SCITUATE PLANNING BOARD MINUTES November 12, 2020

Discussion on Site work related changes – Senior Center – 333 First Parish Road

Mr. Kirby reviewed site changes for the Senior Center at 333 First Parish Road. Mr. Kirby referenced a letter sent to the Planning Board that detailed the before and proposed changes to the site.

Attachment #8 – Trash Enclosure

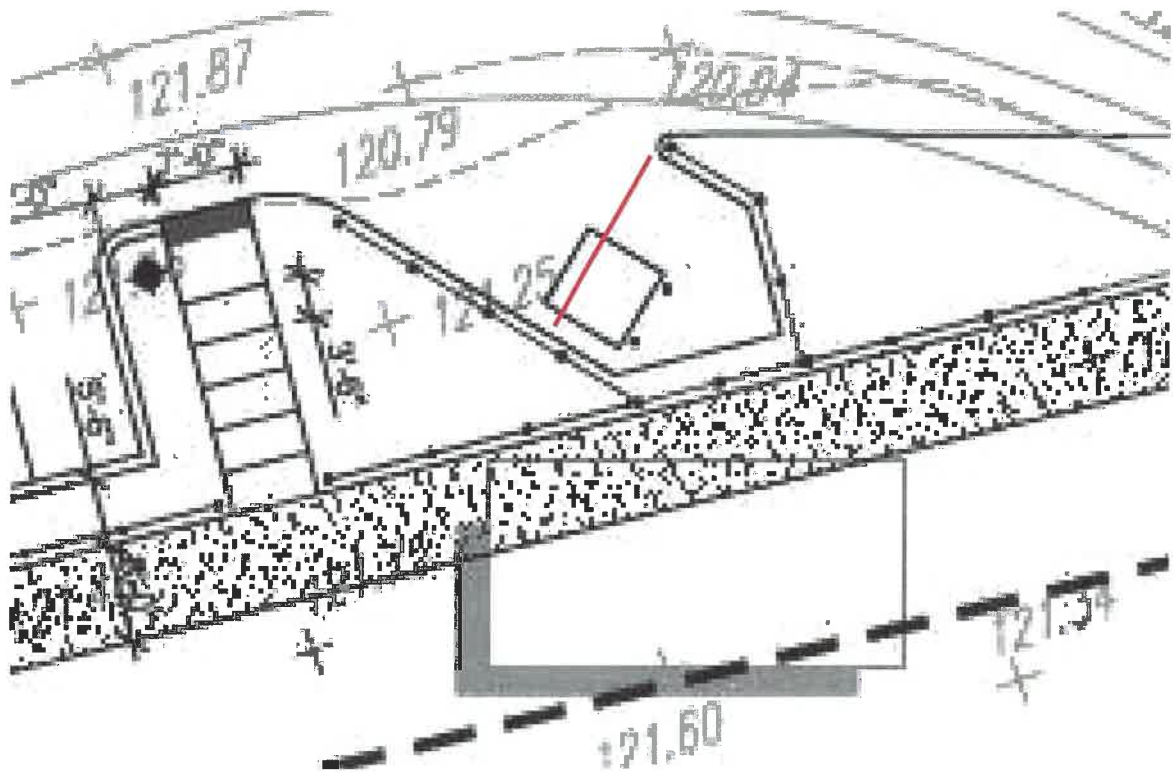
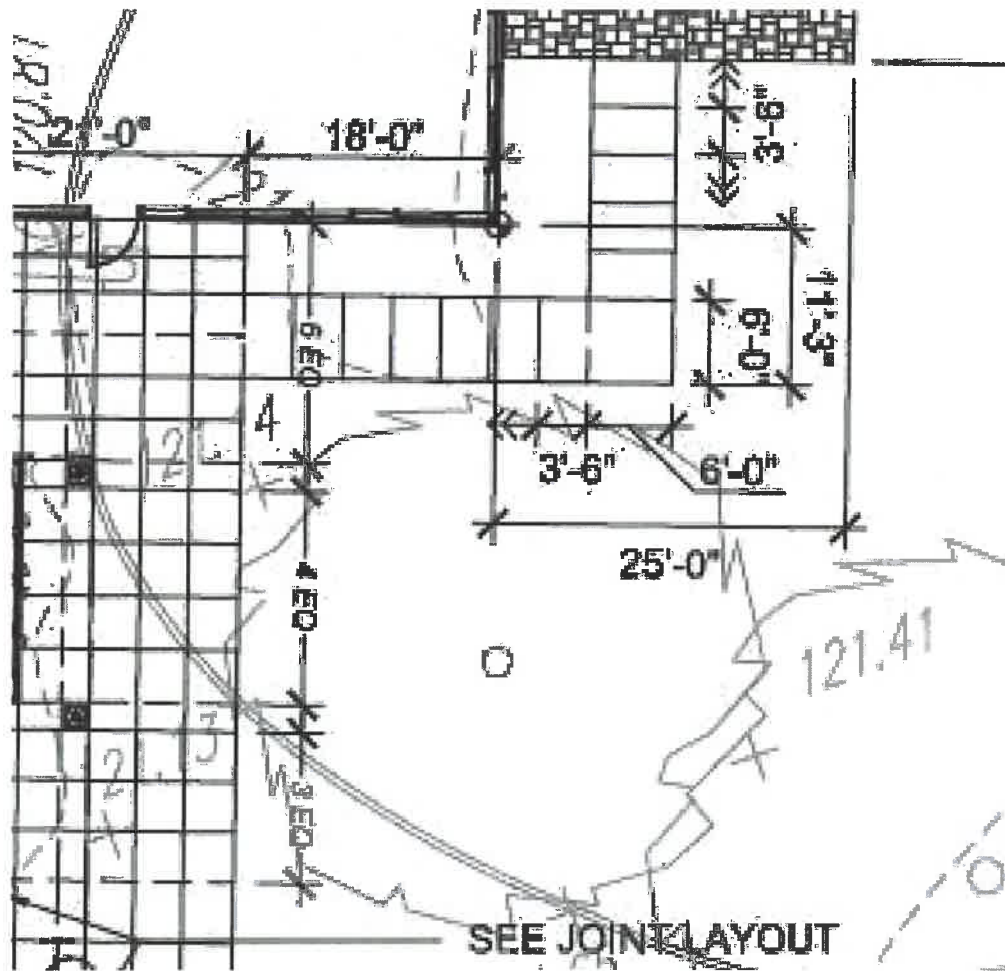
Item #8 – Trash enclosure – fencing to be added along driveway side originally proposed to be open. There will not be a dumpster only barrels. Fencing to prevent trash unrelated to the Senior Center being disposed of in the barrels.

Attachment #9 – Senior Center SE Sidewalk

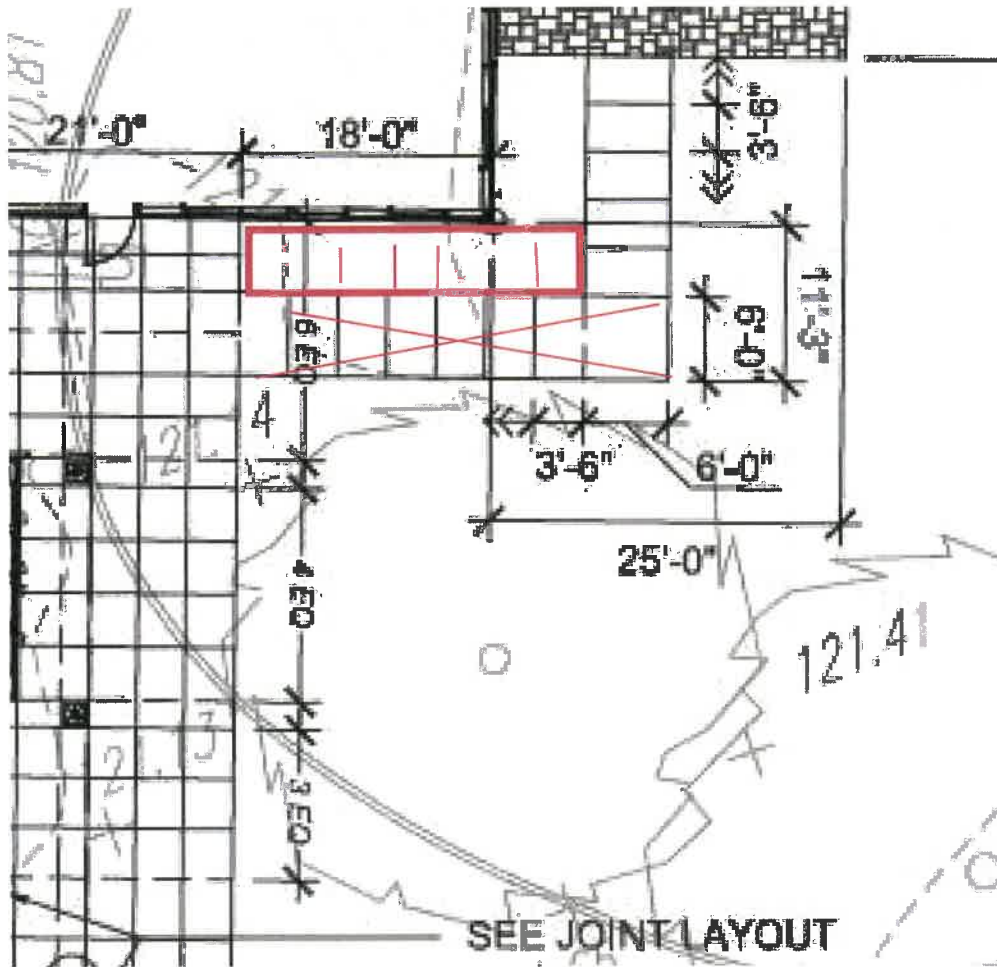
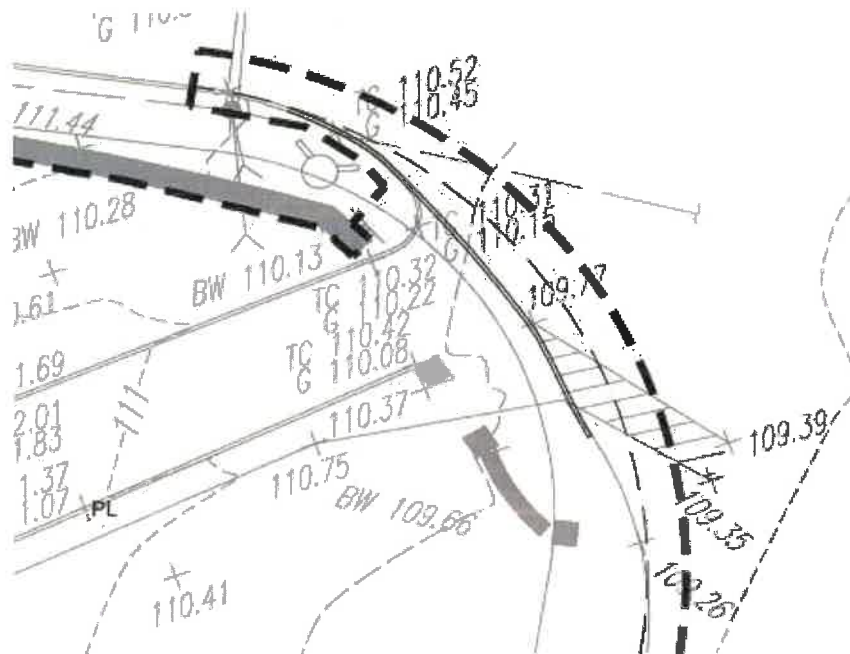
Item #9 – Southeast Sidewalk – pushing sidewalk right next to Senior Center and redistributing plantings to other areas of the site.

Attachment #12 – A Wing Parking Lot Lights

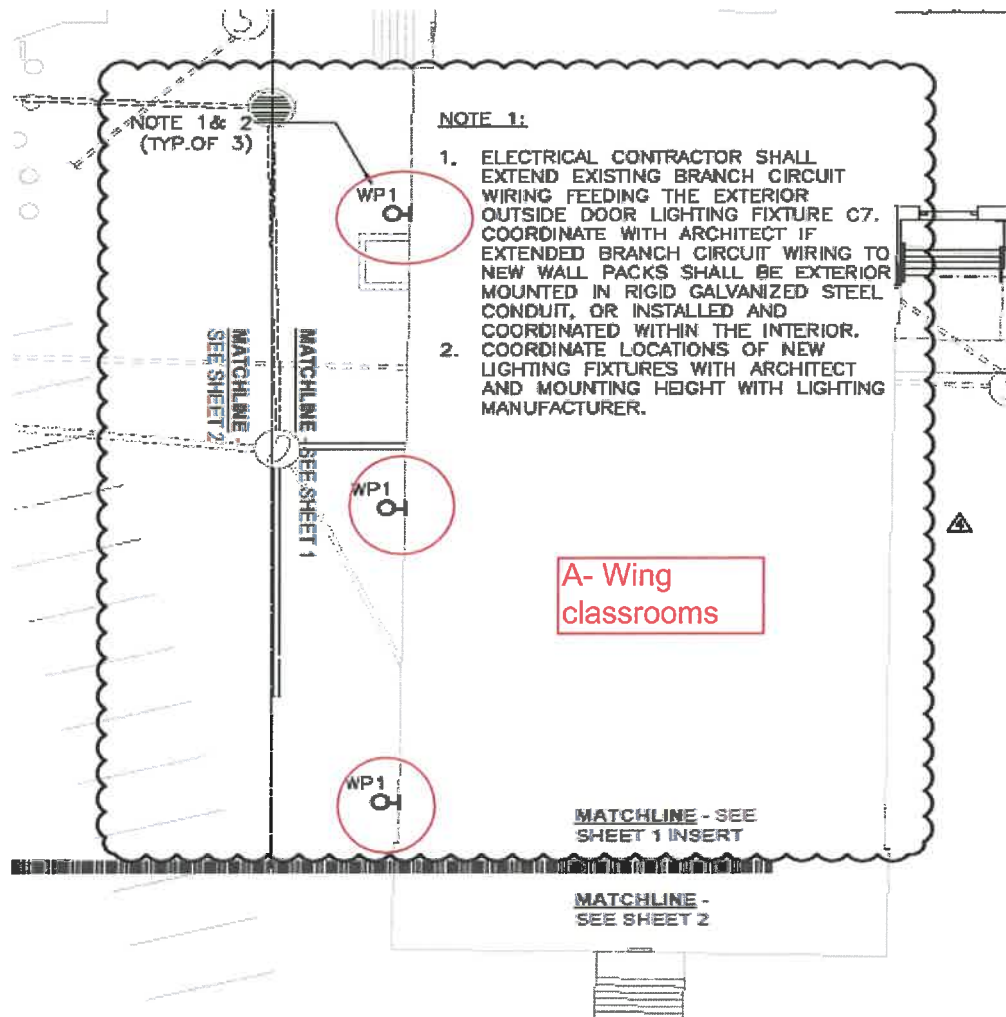
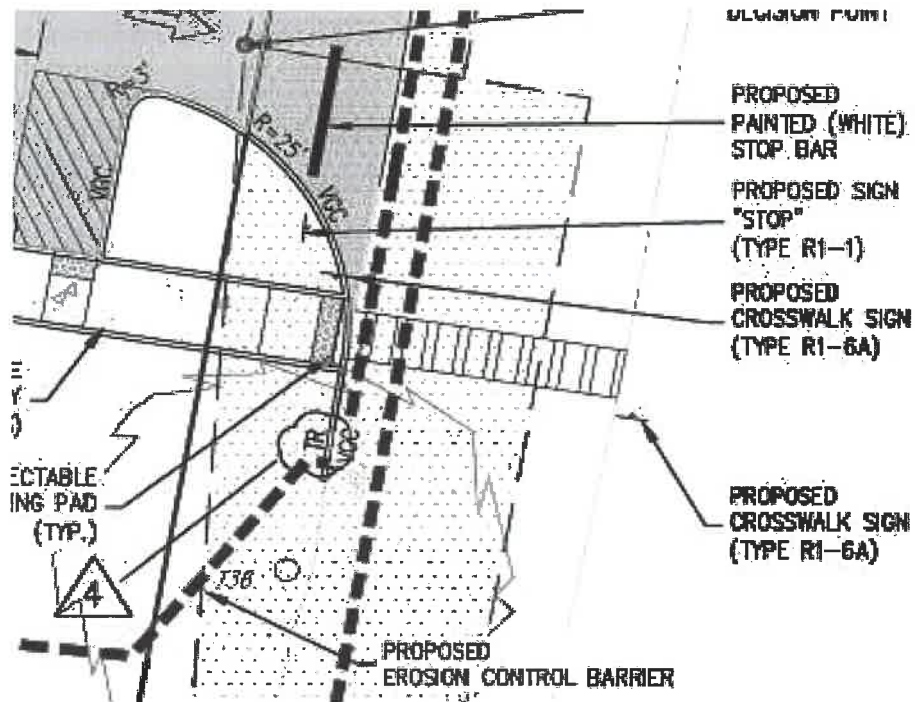
Item #12 – Parking Lot Lighting – change to wall packs on the building vs. light poles at the A Wing parking lot. There is no impact to the lumen level for the area.

Attachment #13 – Cudworth Crosswalk

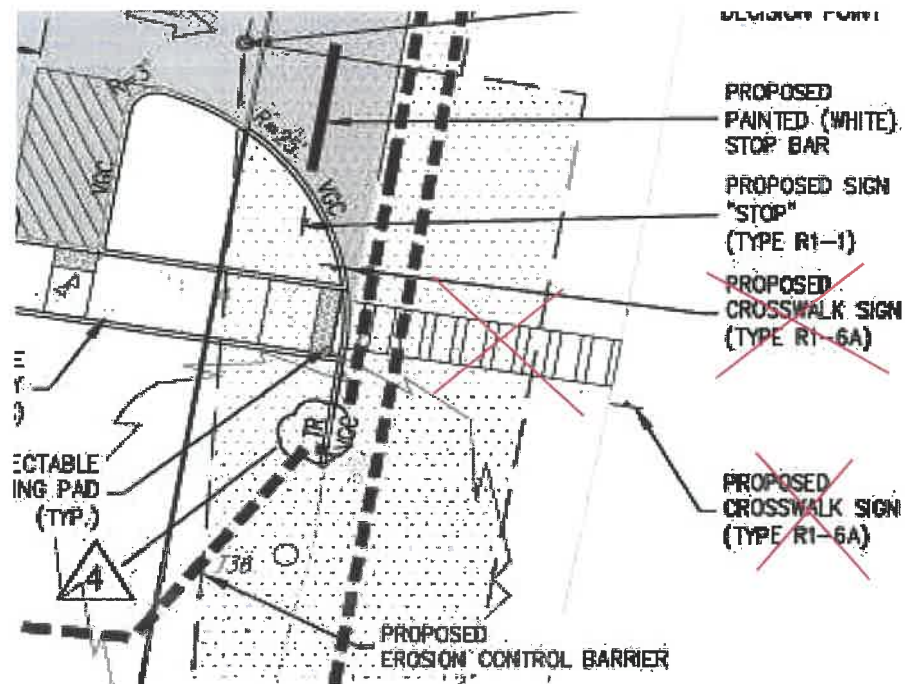
Item #13 – Crosswalk at Cudworth – remove painted crosswalk and not install crosswalk signs, existing side walk not prepared with handicapped accessibility, sidewalk on baseball field side is not part of the contract; did not want to have a crosswalk to a dead end. Prepared on the gym side for a crosswalk if there are any future improvements made on Cudworth.
